REQUEST FOR INFORMATION

TO:	Artie St. Onge	FROM:	Mike Davis / Mike Weigand
COMPANY:	A.L. St. Onge Contractor	DATE:	5/19/16
FAX NUMBER:	802-326-4005	TOTAL NO. OF PAGES INCLUDING COVER:	1 plus Attachment
PHONE NUMBER:	802-326-4792	SENDER'S REFERENCE NUMBER:	RFI #8
RE:	Waitsfield BRF 013-4(39) - Bridge No. 177; VT 100 over Mad River Waitsfield, VT

**RFI #8: Abutment #2: Proposed Uniform Spacing of
Reinforcement in Back Wall Mark No. 'MD-BW4'**

1 REINFORCING PLAN VIEW IN FORM
 BW4.1
 3/4" = 1'-0"

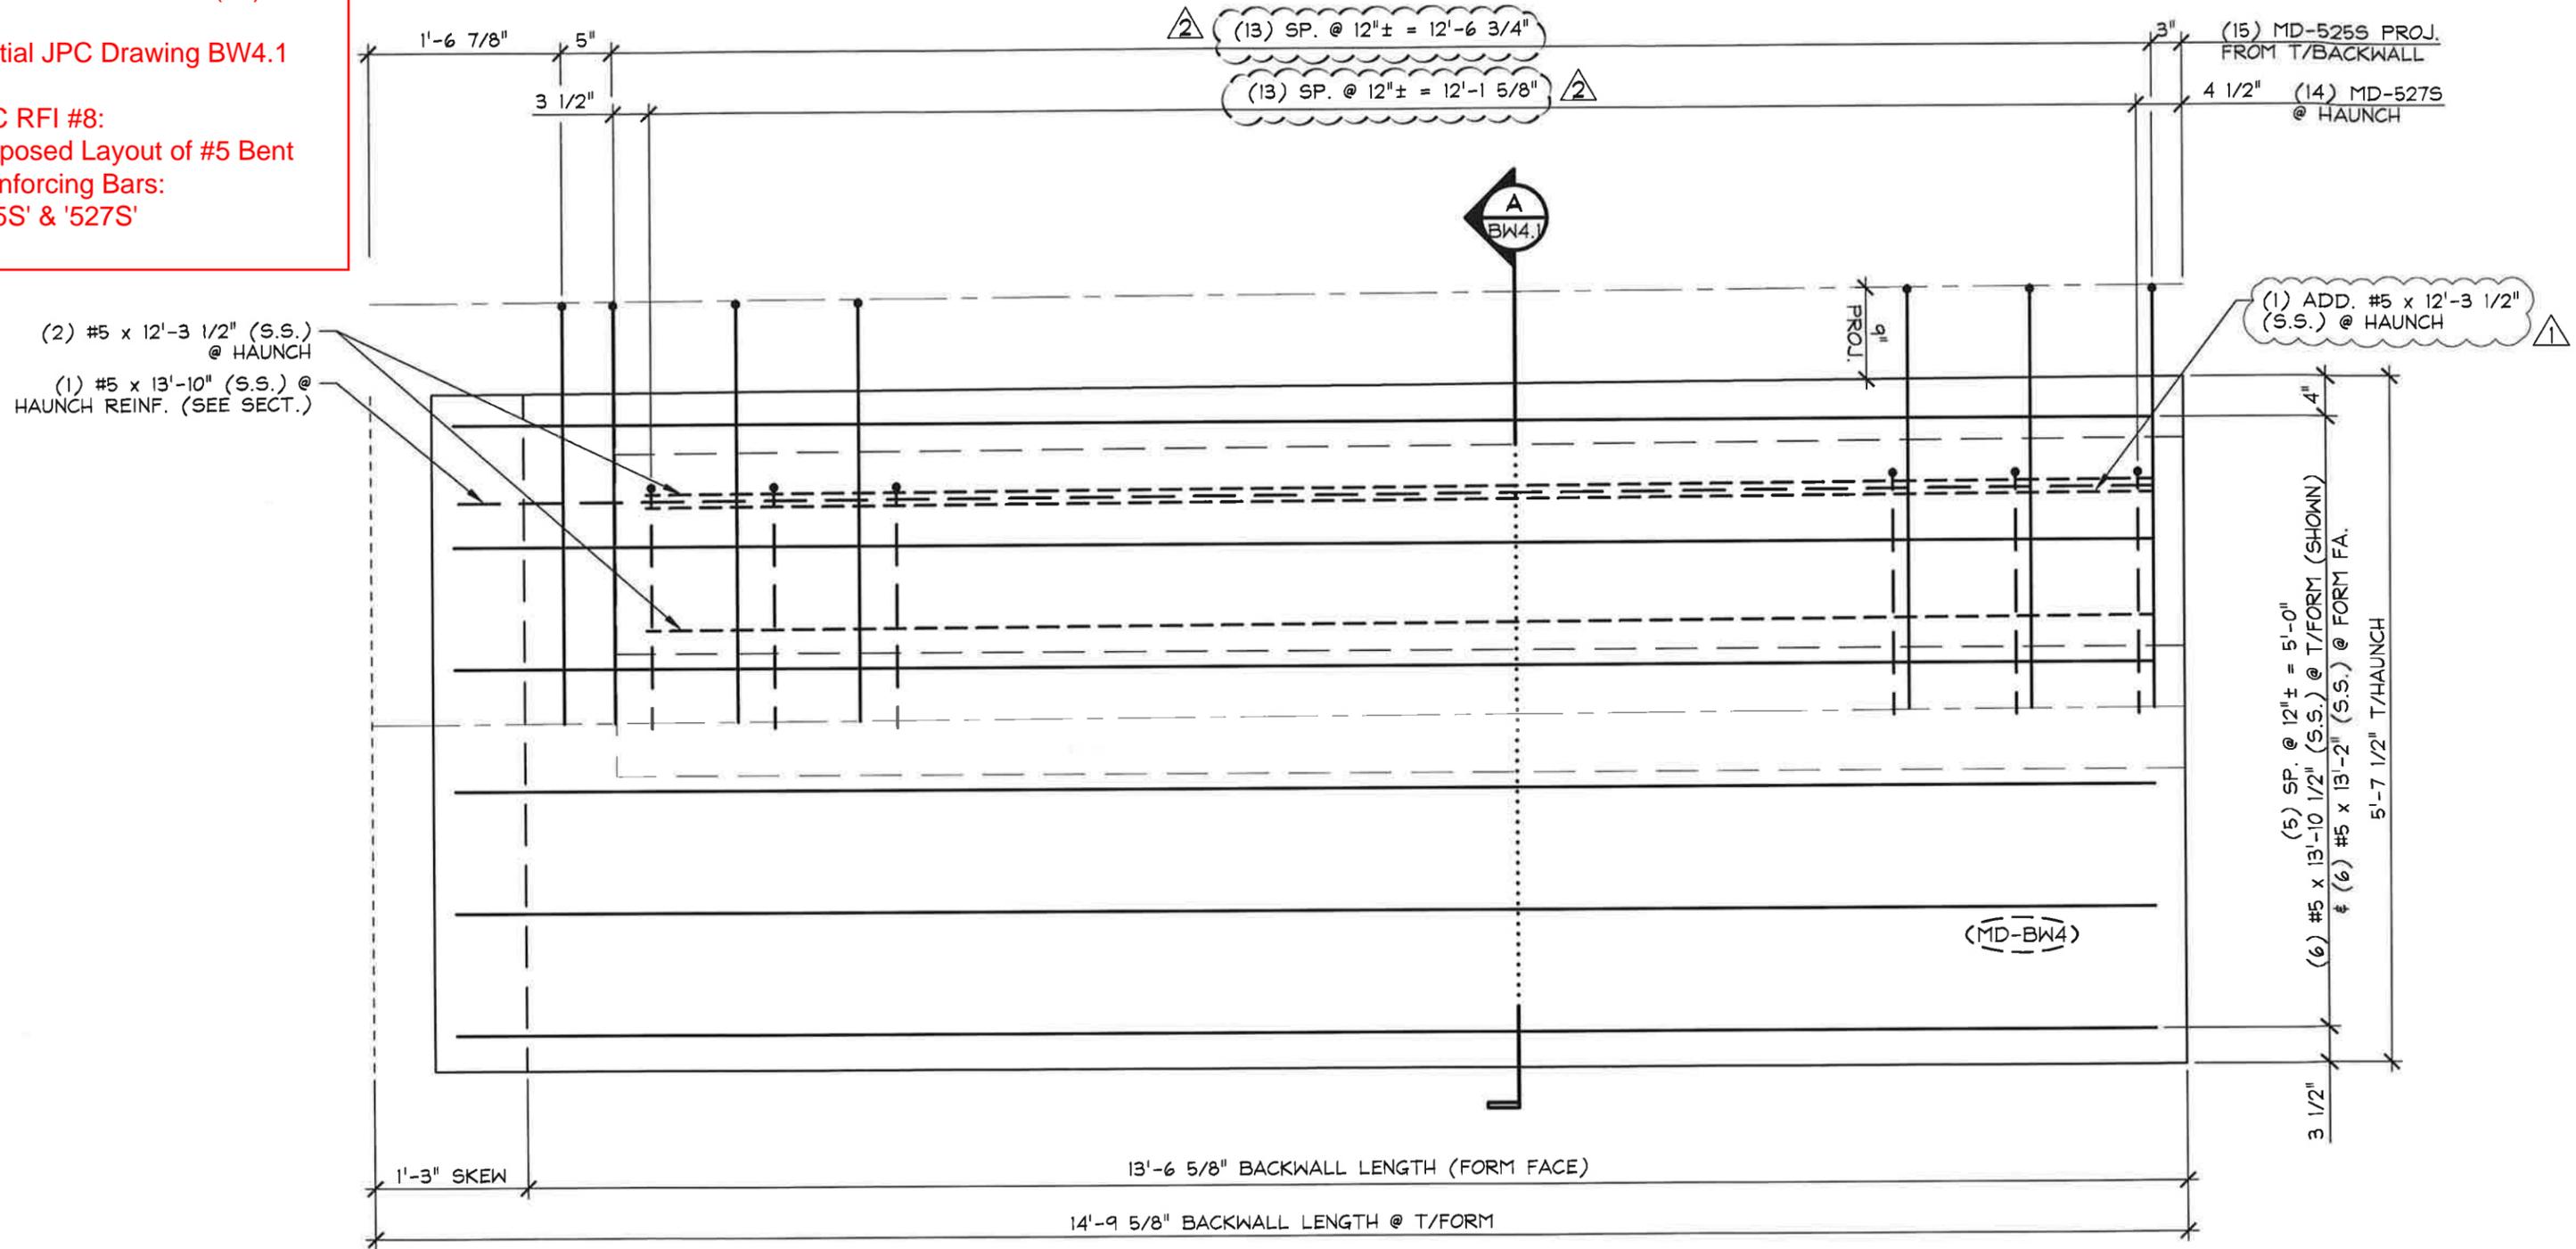
J. P. Carrara & Sons, Inc. "JPC" proposes to modify the spacing of the 'MD-525S' projecting #5 bent bars and the 'MD-527S' corbel #5 bent bars from an uneven spacing as shown in the reinforcing plan view in form 1/BW4.1 in the approved-as-noted shop drawings to 12" +/- on center in the attached sketch. This change is in the interest of forming of the back wall. The overall quantity of each type of bar is unchanged, with a total of (15) 'MD-525S' required and a total of (14) 'MD-527S' required.
